CONNECTION ASSESSMENT & APPROVAL PROCESS ASSESSMENT SUMMARY

**Project: Toronto Fairchild TS
Replace 34.5kV Oil Bus Tie Breaker BY**

CAA ID: 2002 – EX104

Date: February 17, 2003

Figure 1: Toronto Fairchild TS

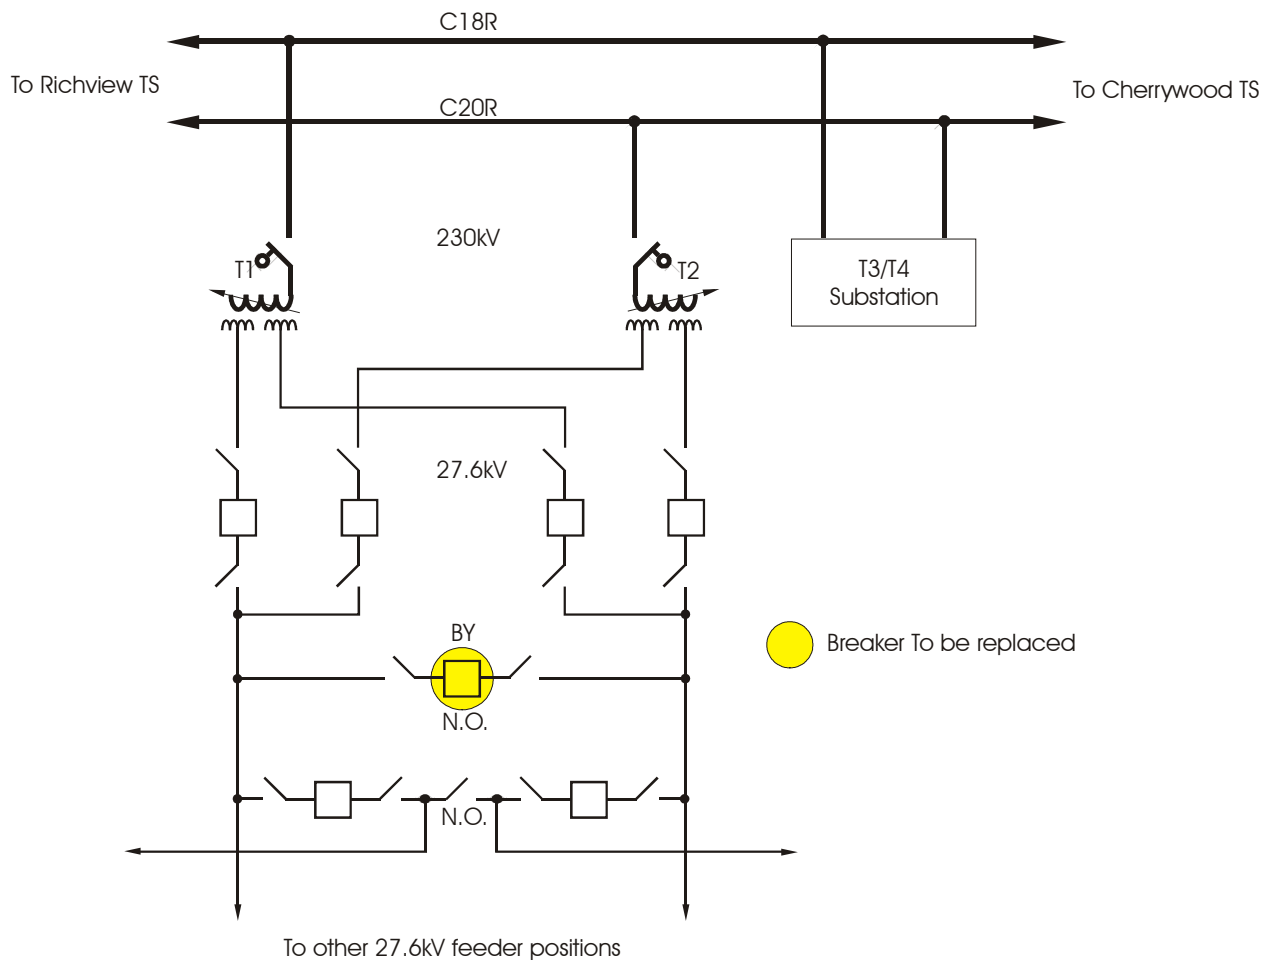
The Toronto Fairchild TS is of ‘Bermondsey’ design, where two step-down transformers with dual secondary windings are connected parallel as shown in Figure 1. The low voltage bus tie breaker at this type of station is normally open to limit the maximum short circuit level at the low voltage bus below 800MVA. However, there are occasions when the bus tie breaker will be closed for a short duration to facilitate load or feeder transfers. During the short instances when the bus tie breaker is closed, the short circuit level at the low voltage bus could, depending on system conditions and configuration, reach 1500MVA or 31.4kA at 27.6kV.

The existing 34.5kV 2000A oil breaker with an interrupting capability of 22kA will be replaced with a new SF₆ unit with an interrupting capability of 31.5kA, which is adequate for the intended duty. The proposal is essentially a like-for-like replacement of existing facility and would have no adverse impact on the IMO-controlled grid.

Based on the above assessment, it is recommended that a Notification of Approval for this proposal be issued to the applicant.
